Project Code & Schematics Subject: MS21 MP Main Board

FOXCONN		HON HAI Precision Ind. Co., Ltd. CCPBG - R&D Division
Title Index Page		
Size A3	Document Number (MS21-1-01)MainBoard (MBX-164) TYPE2	Rev 1.1
Date: Thursday, August 10, 2006	Sheet 1	of 78

MS20 MP to MS21 DVT Change History

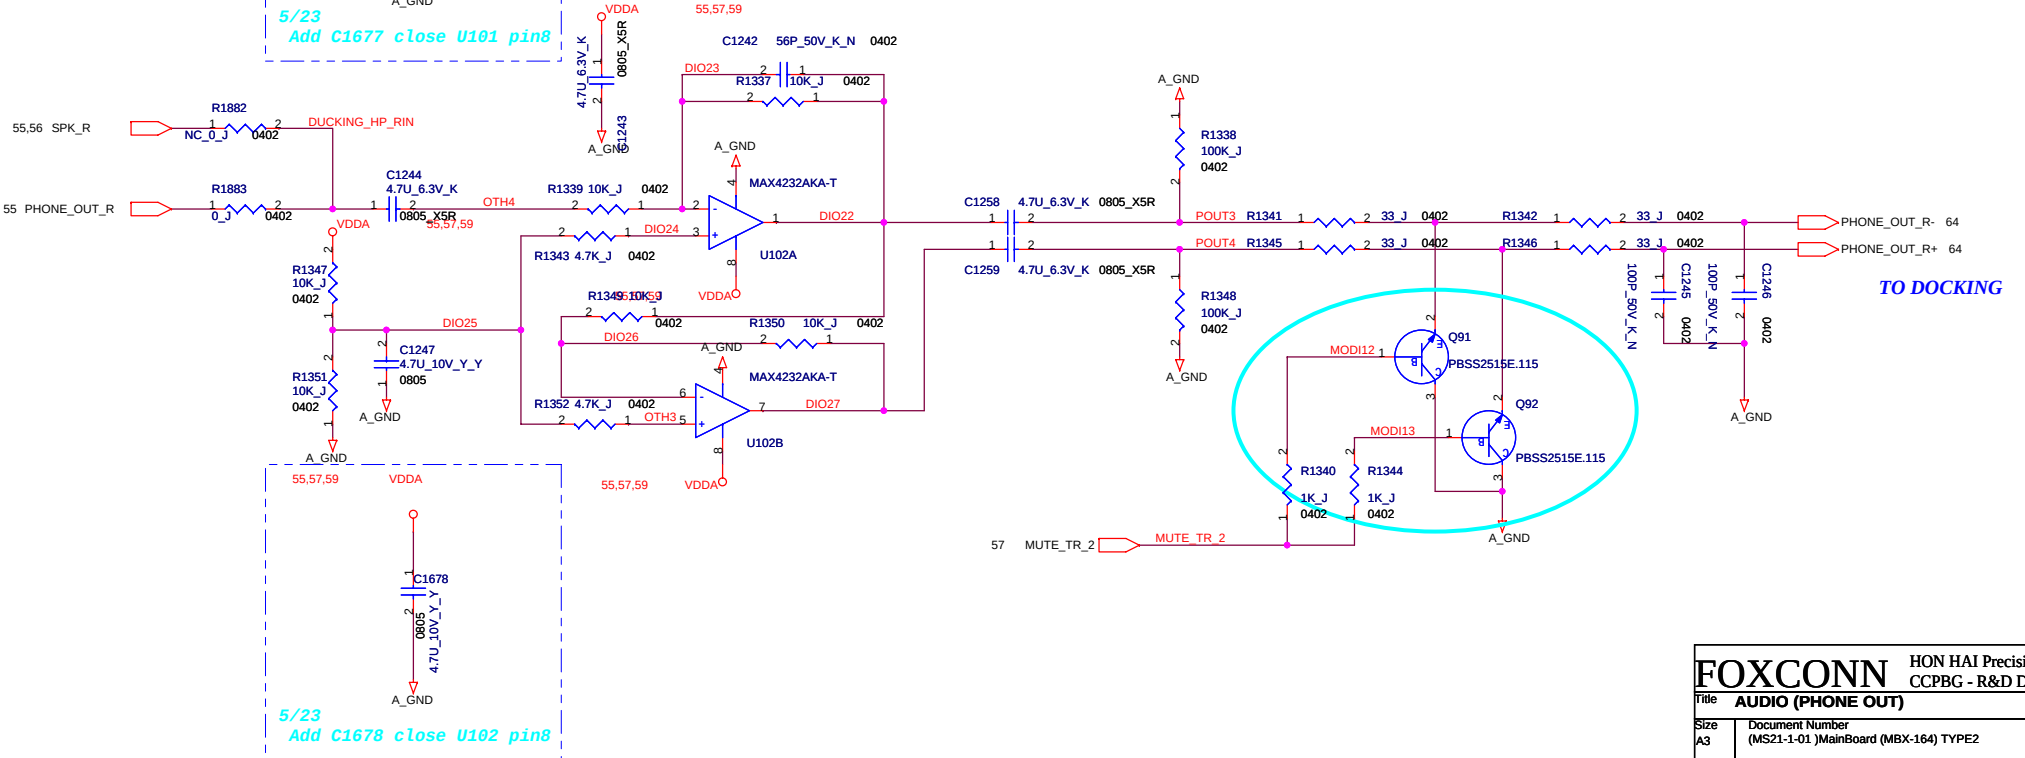
050806: PBSS2515F.115 will EOL
Q89,Q90,Q91,Q92 change to PBSS2515E.115

Audio Board connector

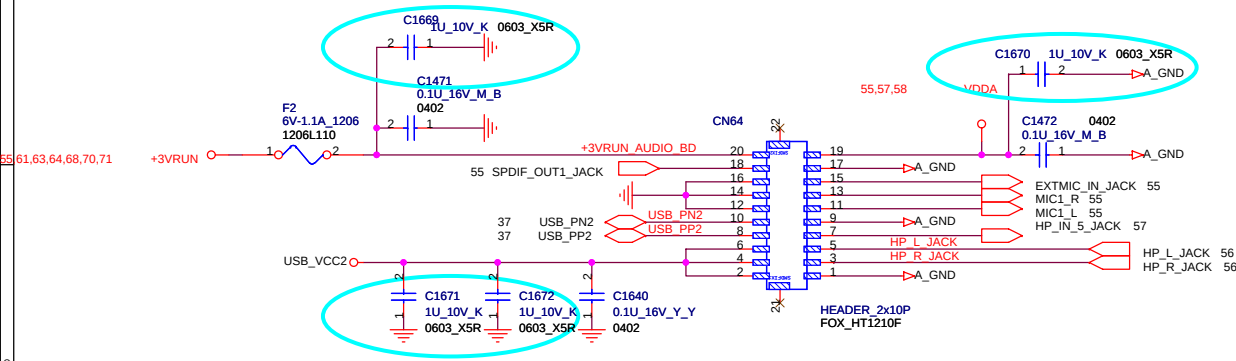
050806: (To improve SNR issue)

Add 1uF capacitors close CN64 :C1671,C1672 on USB_VCC2,
C1669 on +3VRUN_AUDIO_BD, and C1670 on VDDA .

Separate analog ground for digital Noise issue:

- (1) Remove GP3 (Close Jumper) not bridge between GND and A_GND
- (2) Backup two jumper resistors for bridge between GND and A_GND (C1388, C1966 on Screw hole H3, C1957, C1959 on screw hole H5)
- (3) Isolate screw hole H4, add 100pF capacitors C1673, C1674 for EMI, Zener diode D100 for ESD
- (4) Add jumper resistor for Return patch R1955 close L70 & R1958 close U41(+5VRUN) & R1960 close codec.

Constant-Current SONY LOGO LED

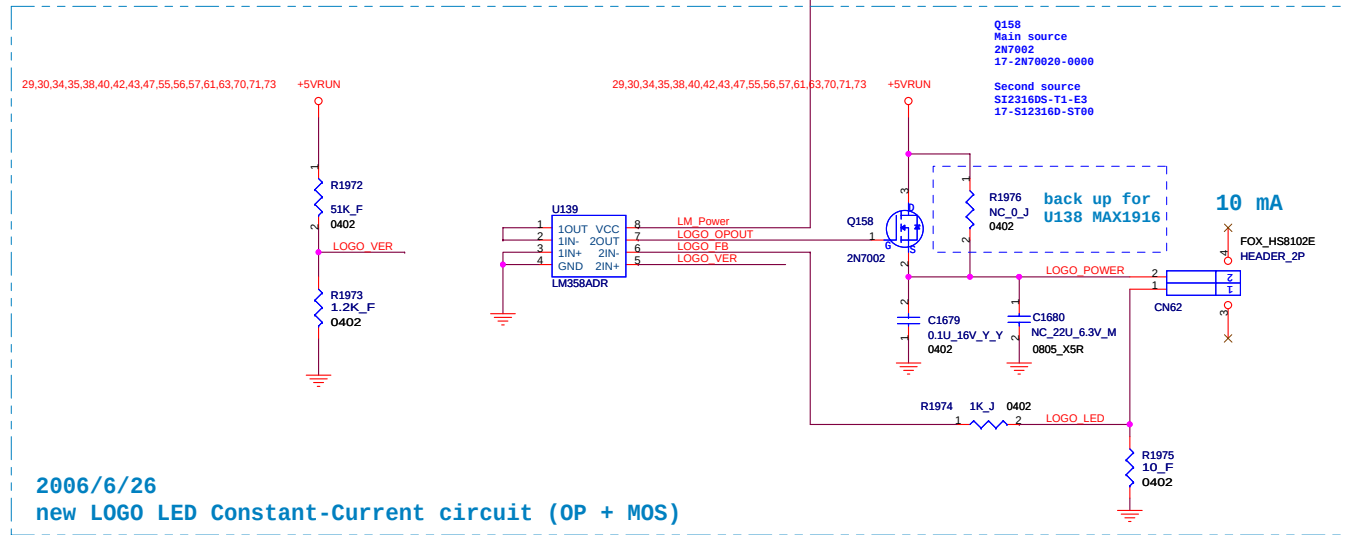
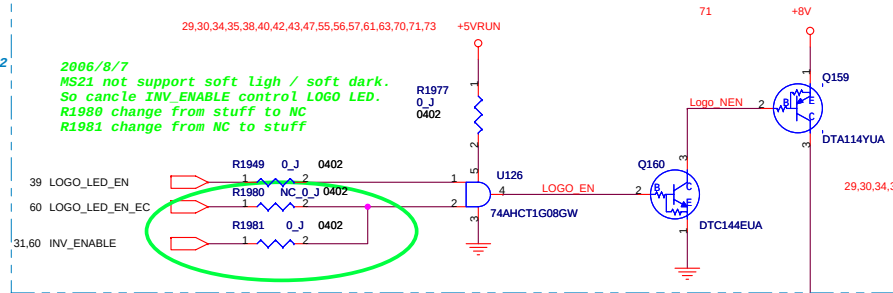
Modify Constant-Current SONY LOGO LED circuit

for U138 cost issue

- 1.Back up:U138(MAX1916EZT),R1936 (91K ohm,0402),R1982(0R,NC),R1983(0R,NC)
 - 2.Remove back up solution U139(GMT,G5920TB1UF),C1660(0.1u)
 - 3.Add new Constant-Current circuit (OP + MOS)
- 51K ohm: R1972 ,
1.2K ohm: R1973 ,
1k ohm:R1974 ,
10 ohm: R1975
(NC)0 ohm: R1976(for back up U138 MAX1916)
0.1uF,16V: C1679
(NC)22uF,6.3V: C1680
OP LM358 ADR : U139
N-MOS 2N7002: Q158
N-MOS DTA114YUA:Q159
P-MOS DTC144EUA:Q160

for EC control soft start/down (function up)issue

- 1.Del R1948(back up LOGO_LED_EN_EC to U126 pin1)
- 2.Serial (Back up) R1981 between INV_ENABLE to U126 pin2
- 3.Move net LOGO_LED_EN_EC from R1948 pin1 to R1980 pin1
- 4.Add R1977 between +5VRUN to U126 pin5(VCC)
- 5.Add R1980 between Logo_led_en_ec to U126 pin2
